SUBJECT : ImageQuest Co., Ltd.
FCC ID: PJIL17A0D083
FCC Part 15 Subpart B Certification

FCC ID : PJIL17A0D083
Model : L17A0D083

• Solution for EMI

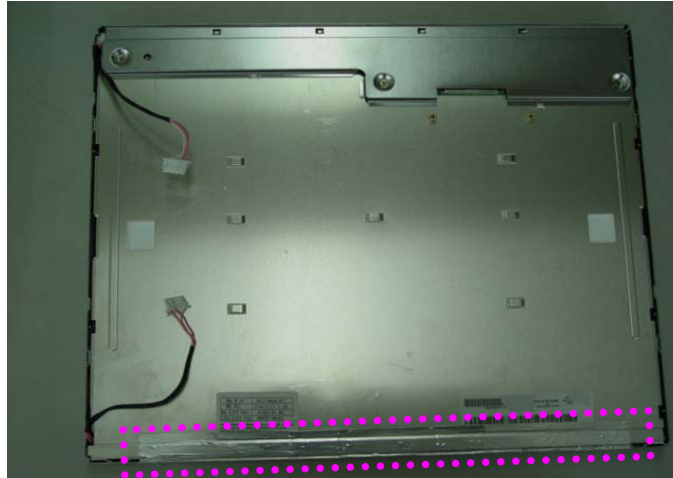
1. Attach a aluminum foil LCD panel Bottom

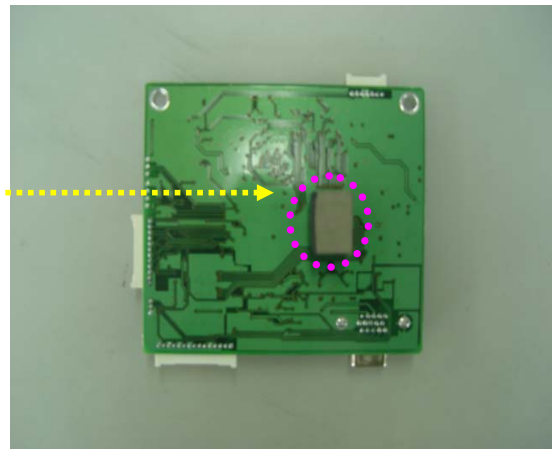
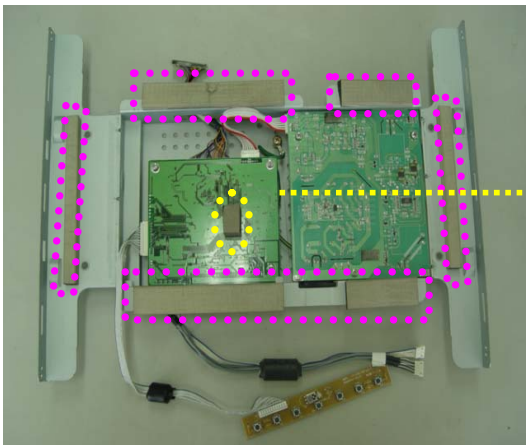
2. Attach a gasket on the Main Board and Main Frame to contact a LCD panel

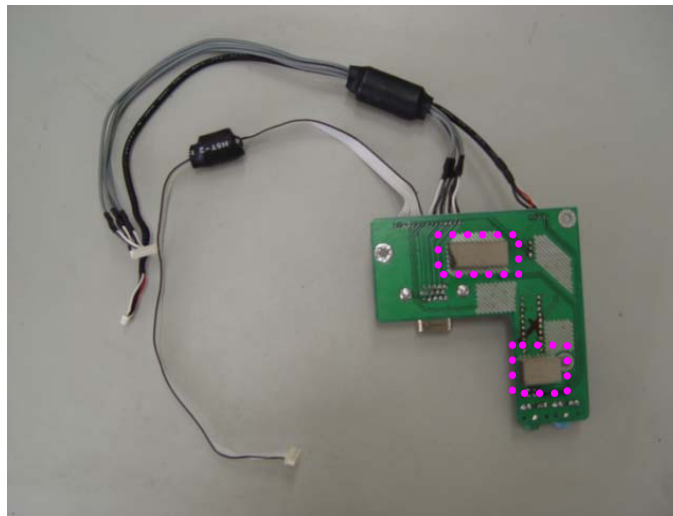
3. Attach a gasket on the Audio PCB to contact a stand

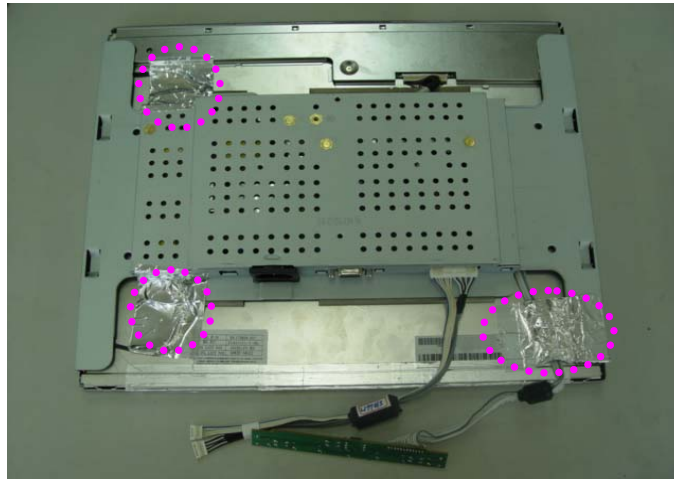
4. Attach a aluminum foil between Main Frame and LCD panel

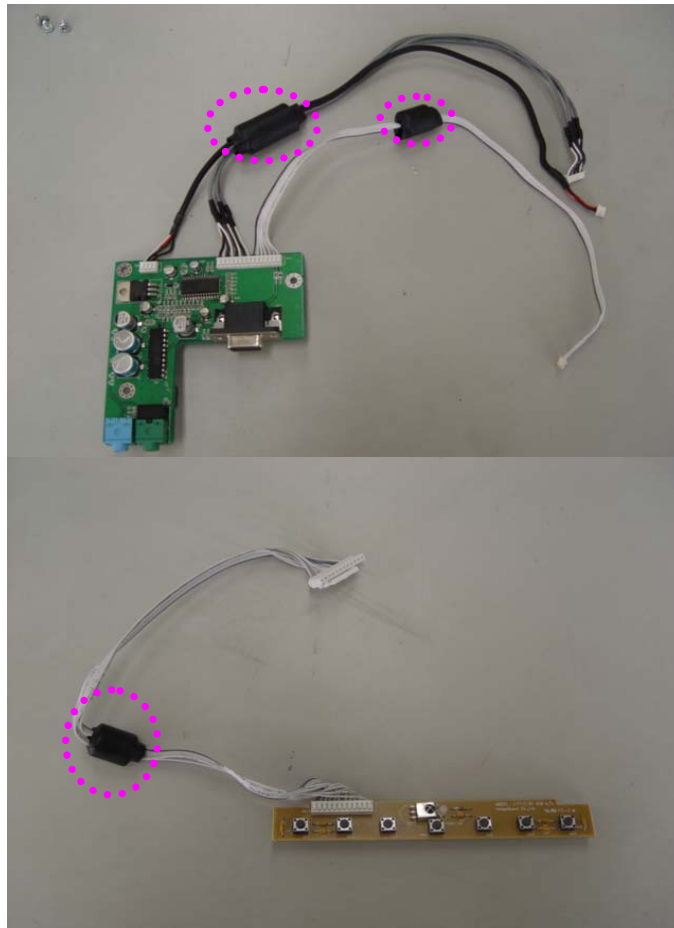
5. Apply a ferrite Core to the Audio Cable, Multi cable and OSD board signal cable

6. The wires which connected MCU and video decoder chip, will be modified with PCB pattern artwork
